**Town of Kittery
 Planning Board Meeting
 February 14, 2019**

ITEM 5 Huntington Run - Cluster Subdivision Final Plan Review

**RE: Town of Kittery, Planning Board Services
Huntington Run Cluster Subdivision
40 Betty Welch Road, Tax Map 66, Lots 2A, 8, & 8A
Review #2
CMA #591.108**

SHEET NUMBER:
C-4.0

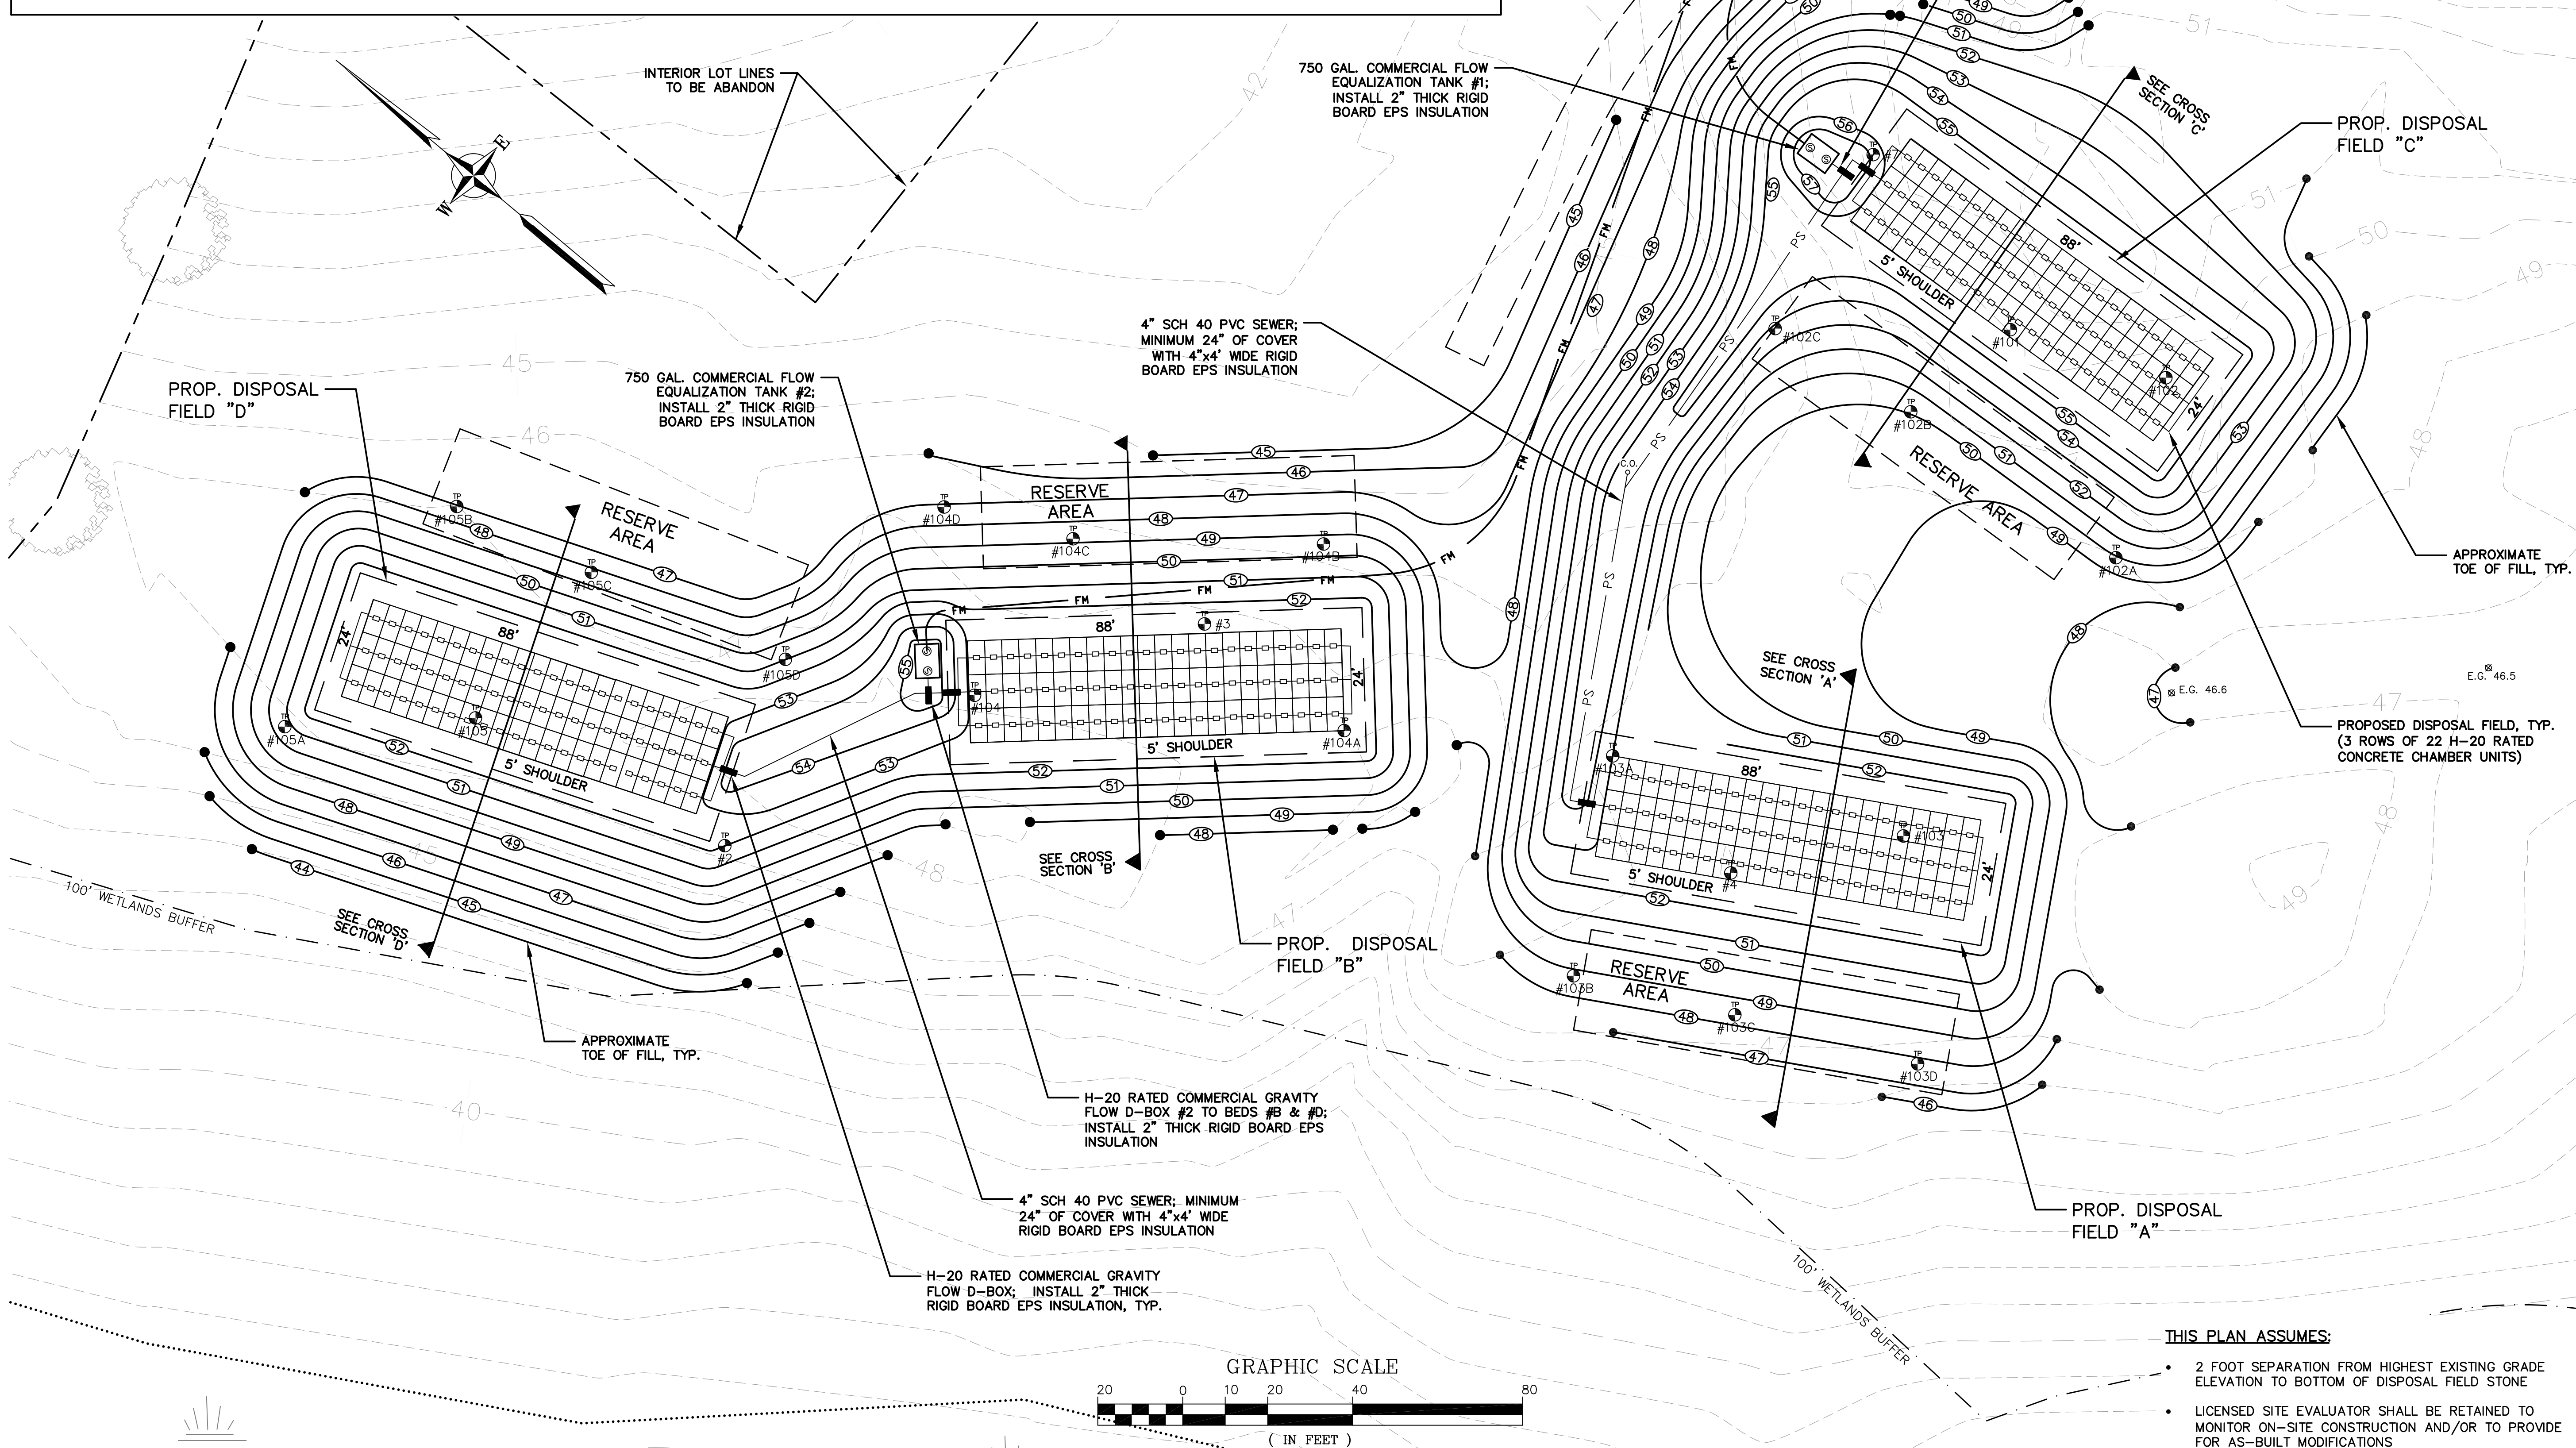
- It's not clear to us how flow will be distributed evenly between the two leachfield pairs. Please clarify.
- Design of the effluent pumping system.
 - Are the individual effluent pumping units supplied by OxyPro or others, such as E-1?

Response: The downgradient fill extends no less than 49 feet from the center of the leaching chambers as shown on the disposal field grading (see Sheet C-4.0) and the cross-sections (see sheet C-4.1). Note that the downgradient fill extensions is at least 32 feet from the 5 foot shoulder as recommended in the attached *Wastewater Mounding and Transmission Analysis* report prepared by Sweet Associates, revised November 20, 2017.

TYPICAL ROADWAY CROSS SECTION (WETLANDS CROSSING)
STA. 0+10 TO STA. 1+10
NOT TO SCALE

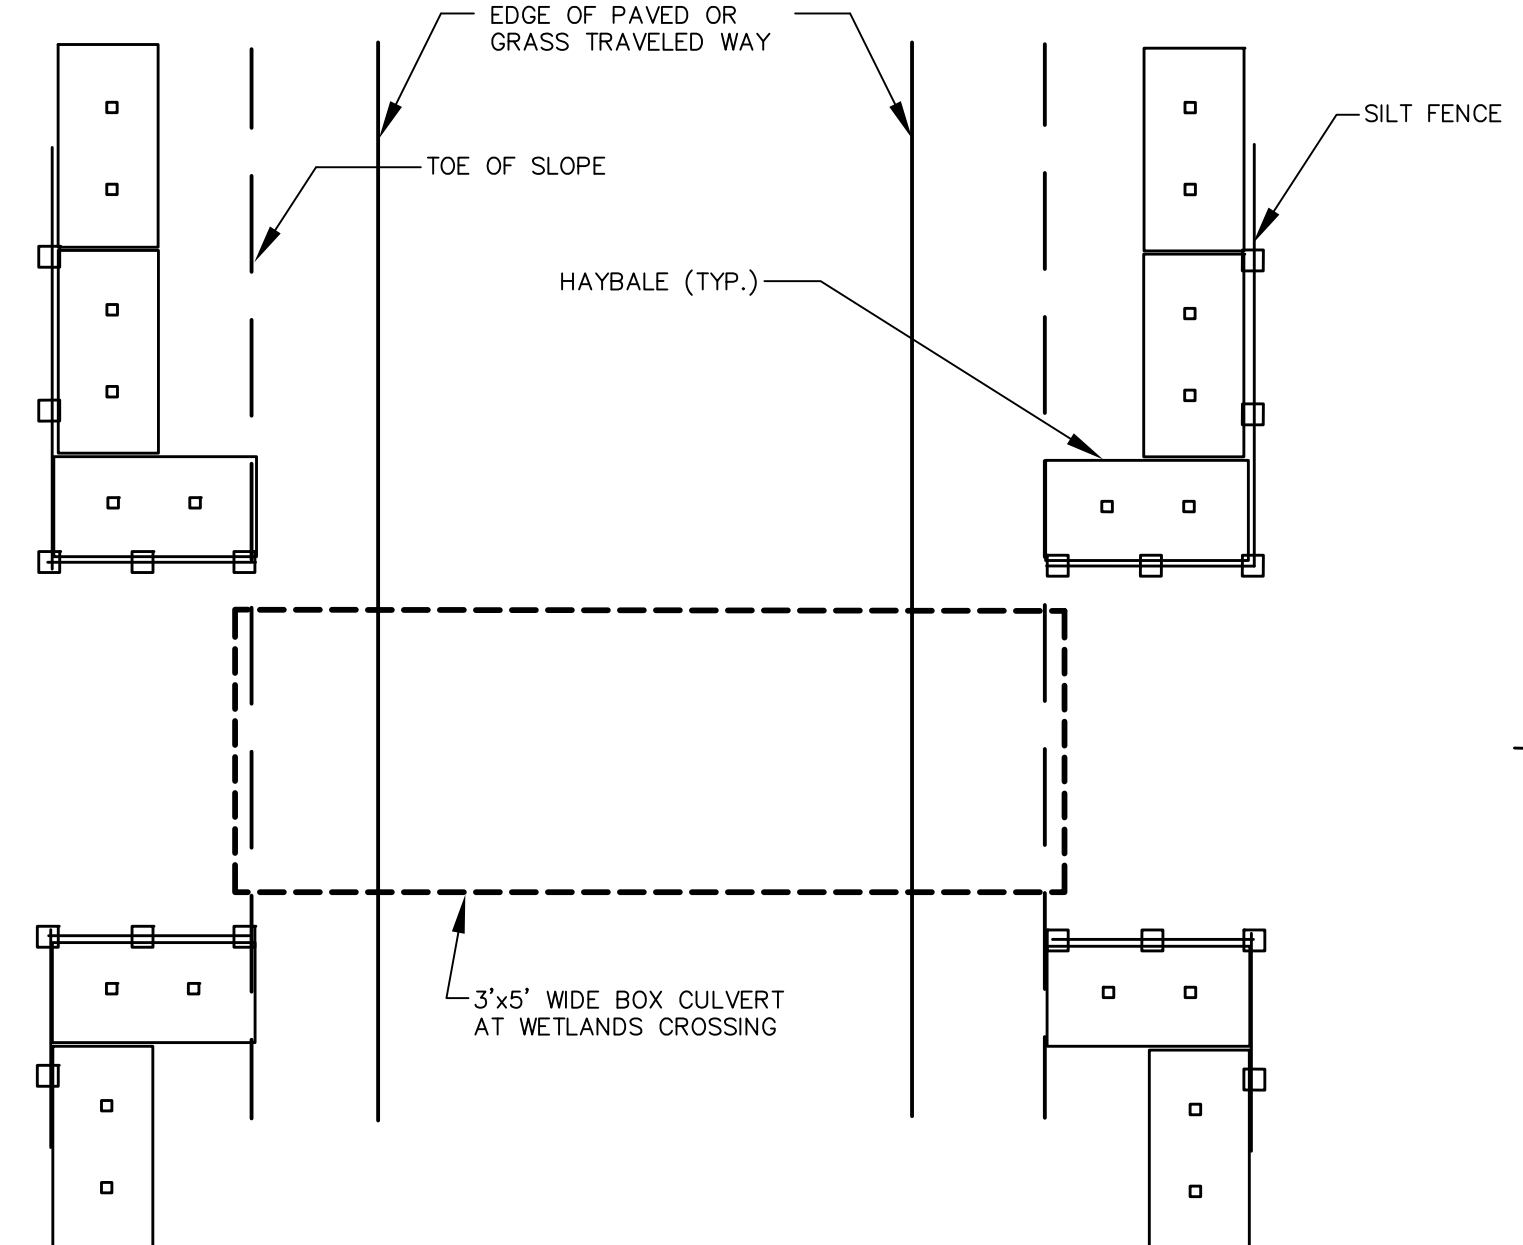
- c) Sidewalk/Pedestrian way-The Applicant has included the minimum 10' paved width for travel-way, not included the required 5' sidewalk in the roadway design; but has included 4' gravel shoulders on each side of the road. The applicant reports that the Planning Board agreed to waive the sidewalk on April 13, 2017. (That should be confirmed in the record).

- d) Paved Shoulder-The standards include paved shoulders in addition to the Travel Pavement. This additional shoulder pavement provides protection to the 10' minimum travel pavement from being chipped/broken/degraded. The proposed road section does not include any paved shoulders. The Applicant should demonstrate that the pavement is protected satisfactorily by either adding a width of paved shoulder (suggest 1-ft minimum; which could be within the 4' gravel shoulder width), or proposing a narrower 9 ft Travel Pavement width, a 1 ft shoulder, and justifying that to the Planning Board.

- Revised roadway to 20' wide pavement with 4' shoulders
- Roadway will be private, maintained by HOA
- Revised G.U.S.F. #1
- Added sedimentation barriers
